**City of Pembroke Pines**  
**Planning & Economic Development Department**  
**601 City Center Way 3<sup>rd</sup> Floor**  
**Pembroke Pines FL, 33025**

<b>Agenda Date:</b>	November 14, 2024	<b>Application ID:</b>	SP2024-0001
<b>Project:</b>	Medsquare	<b>Project Number:</b>	PRJ2024-0001
<b>Project Planner</b>	Cole Williams, Senior Planner		
<b>Owner:</b>	Pines Baptist Church Inc	<b>Agent:</b>	Janna Lhota
<b>Location:</b>	Generally located at the southwest corner of Johnson Street and north Palm Avenue	<b>Commission District</b>	2
<b>Existing Zoning:</b>	PO (Professional Office)	<b>Existing Land Use:</b>	Office Park
<b>Reference Applications:</b>	MSC2004-10, RS2000-04, SP99-53, SUB85-14		
<b>Applicant Request:</b>	Construction of a medical office building including site, architectural, signage, circulation, parking, and landscape improvements.		
<b>Staff Recommendation:</b>	<b>Approval</b>		
<b>Final:</b>	<input checked="" type="checkbox"/> Planning & Zoning Board	<input type="checkbox"/> City Commission	
<b>Reviewed for the Agenda:</b>	Director: 	Assistant Director:

Janna Lhota, agent, is requesting approval to construct a medical office building (Medsquare) with associated site

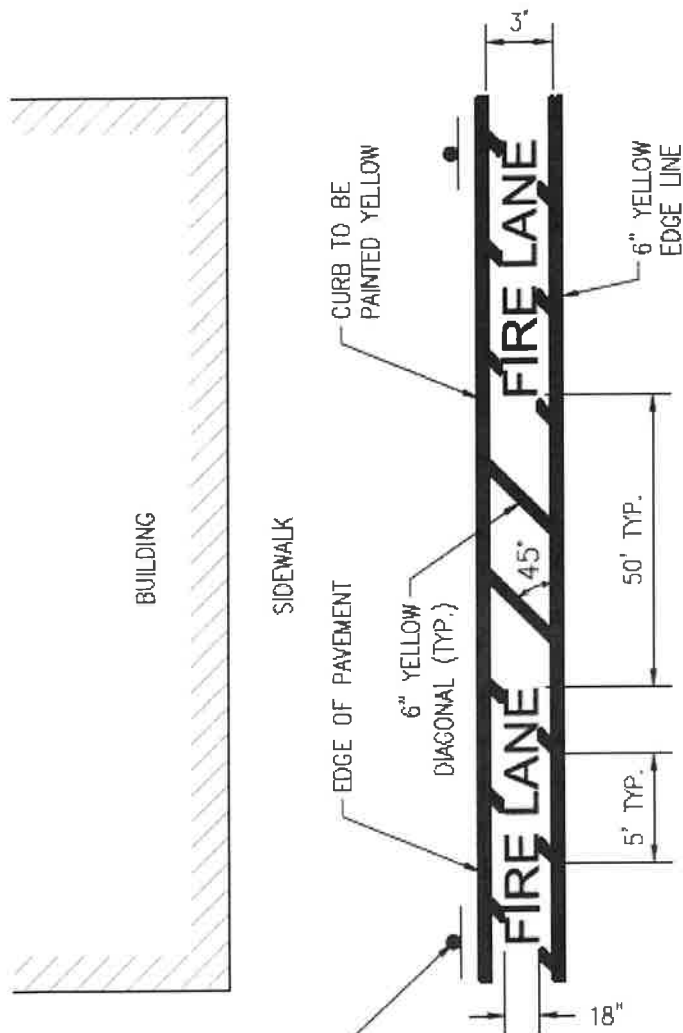
**NOTE:** Include all fire related pavement markings on Fire Access Sheet

**1. Place notes on plan and demonstrate, please show all inside, centerline and outside radius on truck path:** Fire access roads shall be a minimum centerline turning radius of 50'. Show min. 38' inside radius and min 62' outside radius throughout area. Show a shaded truck route including entering and leaving the site with the above turning radius numerals on plans shown throughout.  
***COPP Engineering department verification is required***

**Note:** "All centerline turning radii must be a minimum 50 feet." **COPP CO 154.35 (3)**

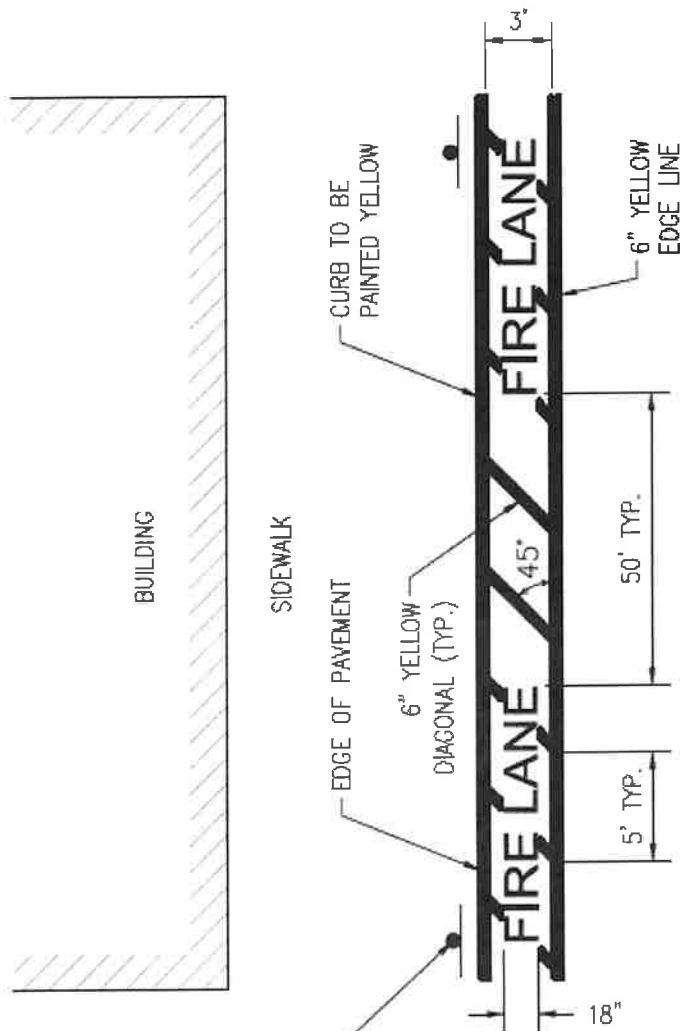
**24. Place note on plan:** In all **new** and **existing** buildings, minimum radio signal strength for fire department communications shall be maintained at a level determined by the AHJ.  
**NFPA-1:11.10.1**

The Owner's Rep or GC shall conduct a Preliminary Initial Assessment to determine if the minimum radio signals strength for fire department communication is in compliance with Broward County standards.
